TOWN OF CARMEL
ENVIRONMENTAL CONSERVATION BOARD

ENVIRONMENTAL CONSERVATION BOARD AGENDA

RE: G&F Subdivision Road,
Gateway Summit and The Fairways
Housing Developments
US Route 6, Town of Carmel, Putnam County, New York

TRAIL PLAN FOR MAINTENANCE BOND

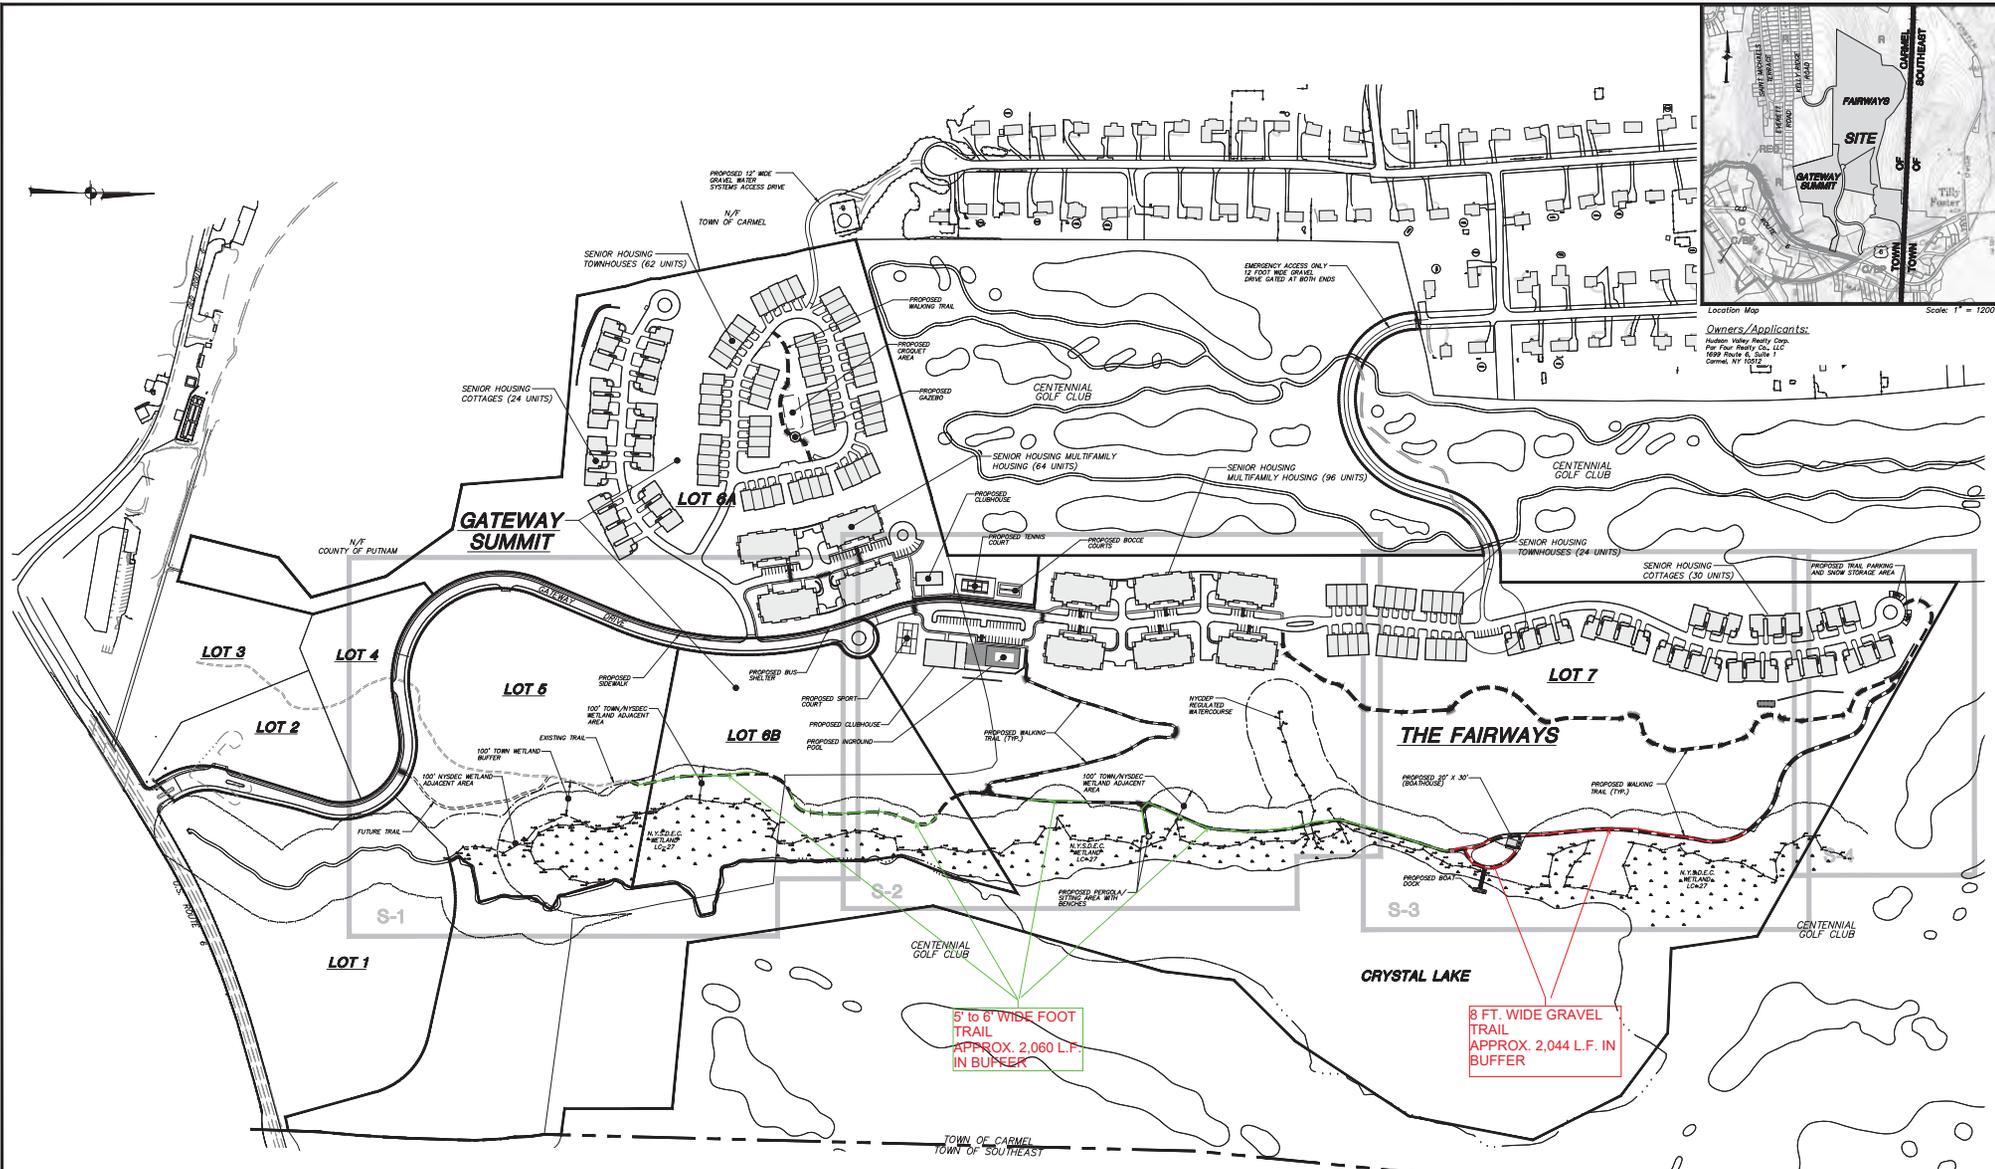
I have reviewed the attached drawings, the email below and the following proposed bond amount for maintaining the trails in the buffer:

- 2 man landscape crew \$1000/day
- Misc small tools and supplies \$500/day
- 2days x \$1500/day = \$3000.

The amount proposed is sufficient for the work proposed.
